Agenda
Village of Arlington Heights
Design Commission
Community Room, 3rd Floor

Arlington Heights Village Hall
33 S. Arlington Heights Road
Arlington Heights, IL 60005
February 14, 2017
6:30 PM

MINUTES OF
THE VILLAGE OF ARLINGTON HEIGHTS
DESIGN COMMISSION MEETING
HELD AT THE ARLINGTON HEIGHTS MUNICIPAL BUILDING
33 S. ARLINGTON HEIGHTS RD.
JANUARY 24, 2017

PROPOSED CONTEXT ELEVATION
SCALE 3/32" = 1'-0"

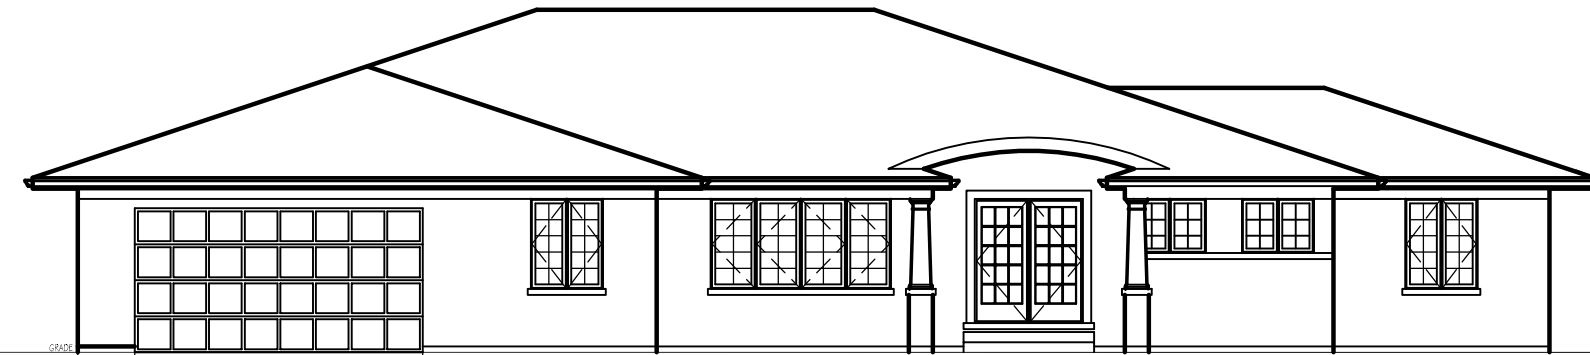
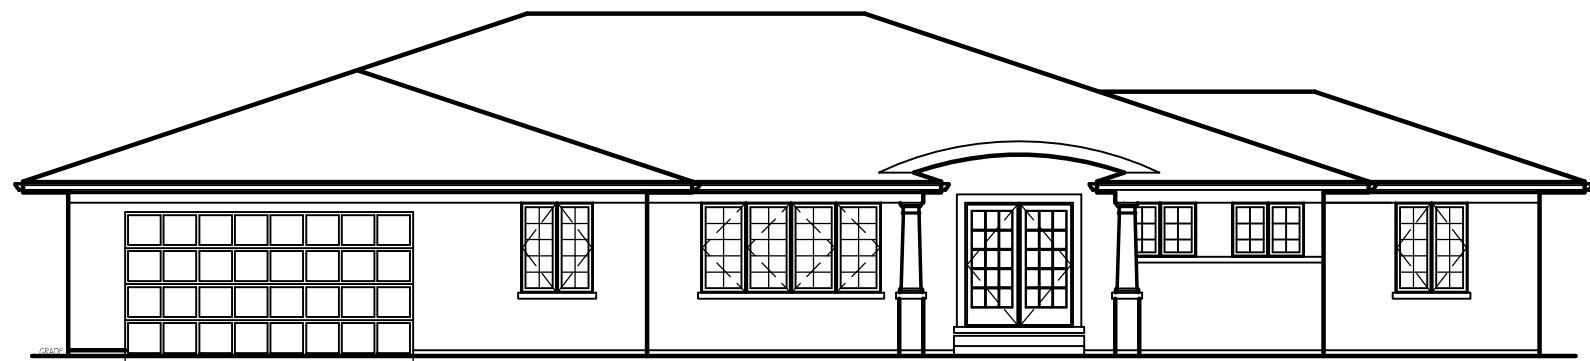
1. Provide landscaping along the side walls.
2. Either adjust the front porch depth, or apply for a zoning variation.
3. This review deals with architectural design only and should not be construed to be an approval of, or to have any other impact on, any other zoning and/or land use issues or decisions that stem from zoning, building, signage or any other reviews. In addition to the normal technical review, permit drawings will be reviewed for consistency with the Design Commission and any other Commission or Board approval conditions. It is the architect/homeowner/builder's responsibility to comply with the Design Commission approval and ensure that building permit plans comply with all zoning code, building permit and signage requirements.
4. Compliance with all applicable Federal, State, and Village codes, regulations and policies.

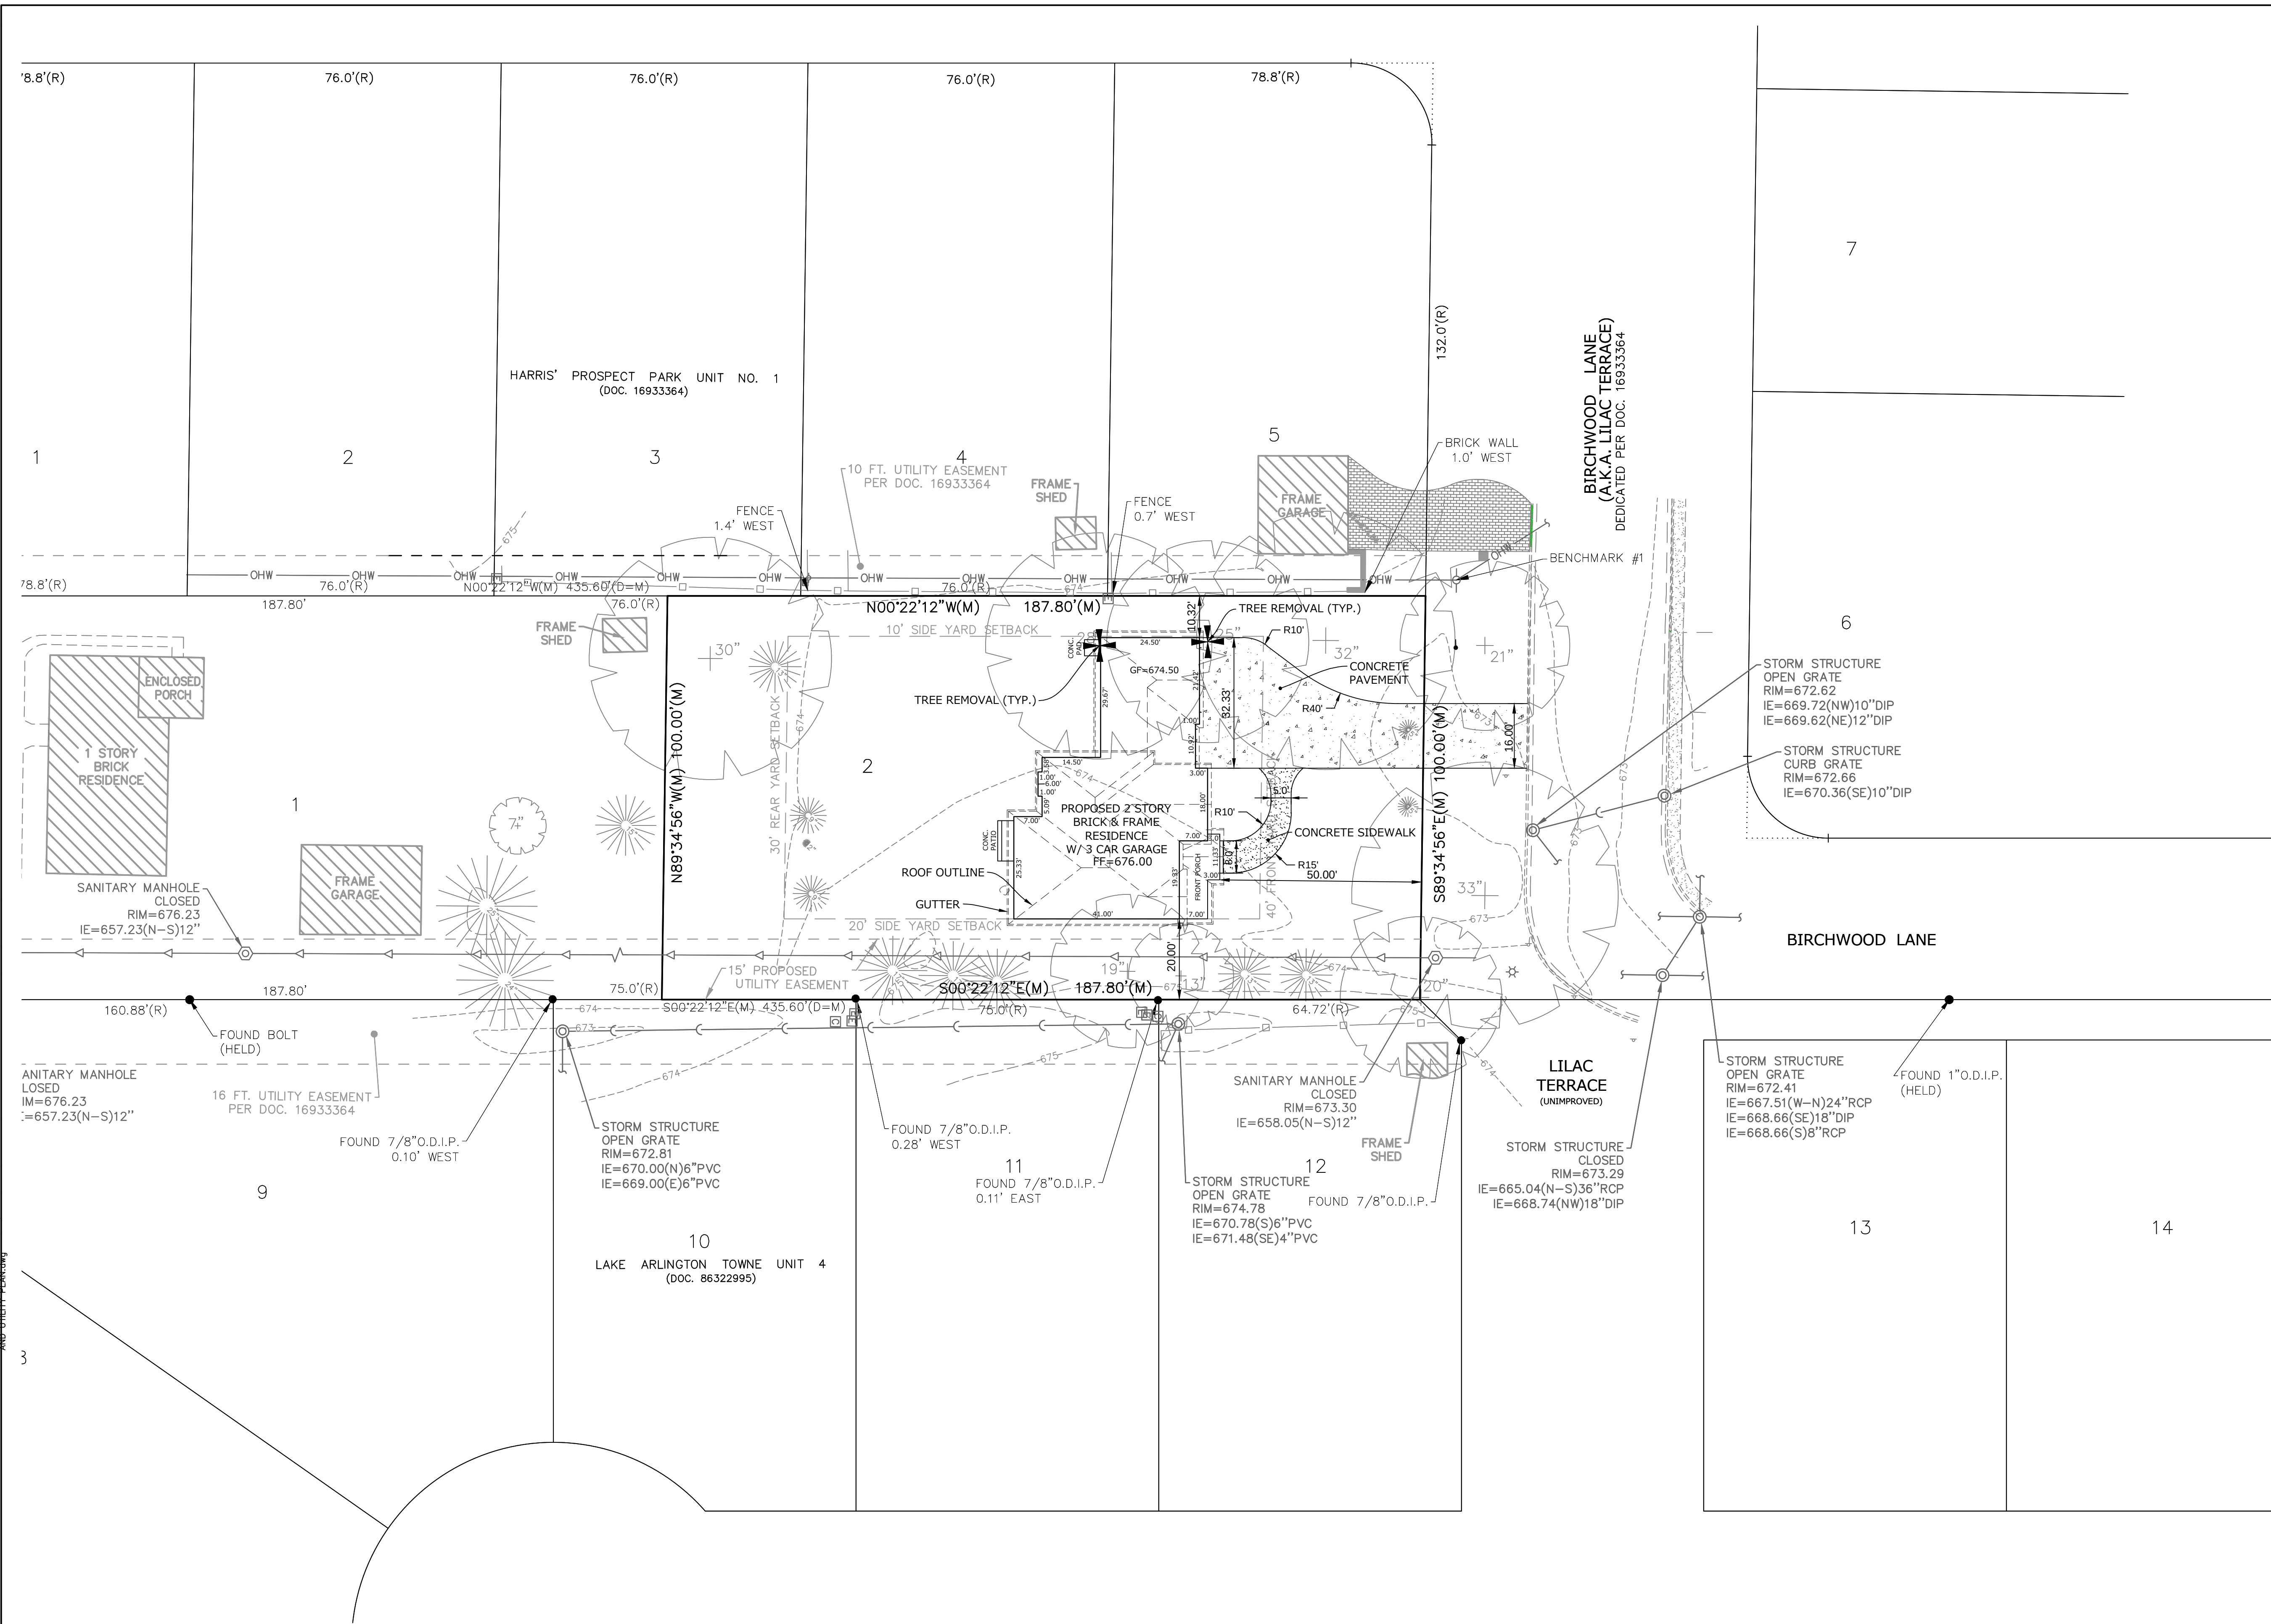
This neighborhood consists of a mix of single-story and two-story homes. The proposed house is nicely designed, and it fits comfortably on the large lot. The garage is setback from the front of the house, keeping the focus on the front of the home instead of the garage. The only comment on the proposed design is that the house is proposed to be setback 50 feet, where the majority of the homes in the neighborhood are setback approximately 25 feet. The Design Commission should evaluate if a 25 foot setback would be more appropriate for a new house in this location.

1. Consider whether a 25 foot front setback would be more appropriate than the proposed 50 foot setback.
2. This review deals with architectural design only and should not be construed to be an approval of, or to have any other impact on, any other zoning and/or land use issues or decisions that stem from zoning, building, signage or any other reviews. In addition to the normal technical review, permit drawings will be reviewed for consistency with the Design Commission and any other Commission or Board approval conditions. It is the architect/homeowner/builder's responsibility to comply with the Design Commission approval and ensure that building permit plans comply with all zoning code, building permit and signage requirements.
3. Compliance with all applicable Federal, State, and Village codes, regulations and policies.

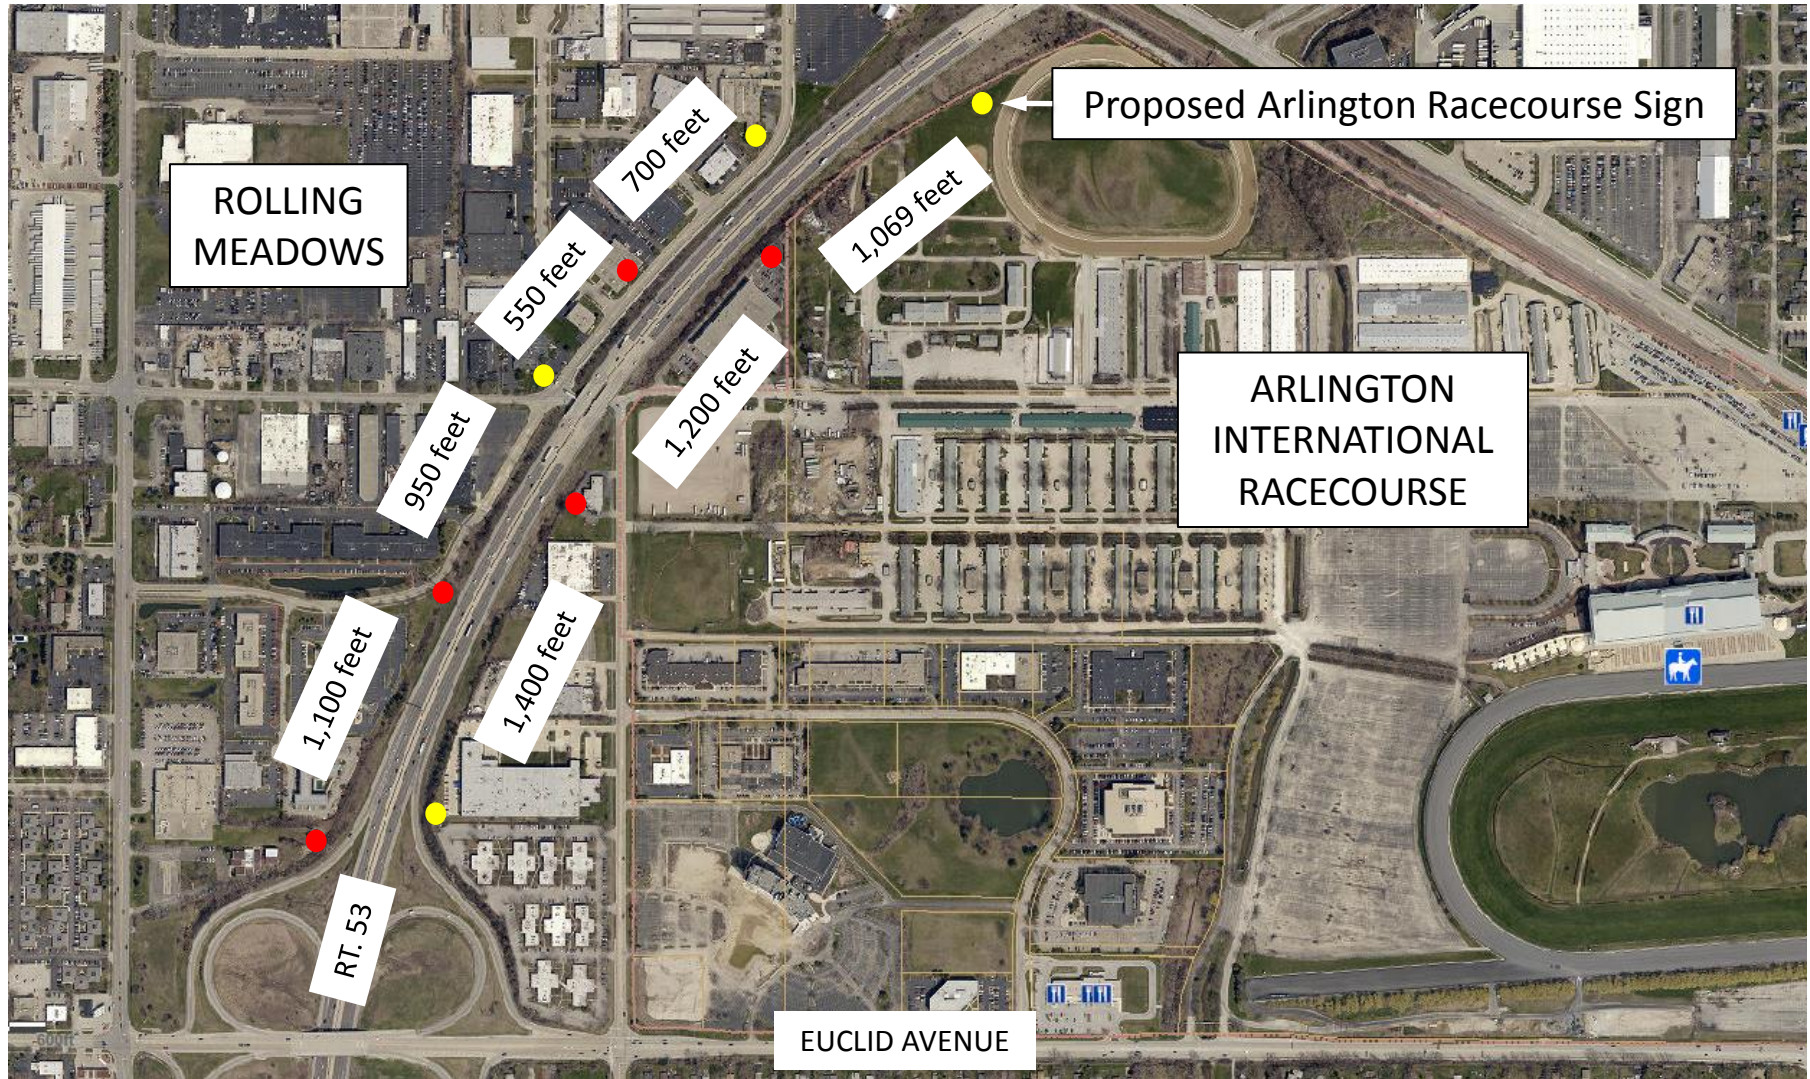
1. The design of the sign shall be revised to include permanent "Arlington International Racecourse" signage on the top of the sign. (Note: The maximum permitted sign size will need to be coordinated with IDOT requirements.)
2. The display on the sign shall be static only. Oscillating, rotating, flashing, intermittent, moving lights, and video are not allowed.

6. Brightness shall be limited to .3 footcandles maximum above ambient lighting conditions at 150 feet from the sign face.
7. Written certification from manufacturer is required to verify auto-dimming function, preset not-to-exceed .3 footcandles above ambient lighting conditions.
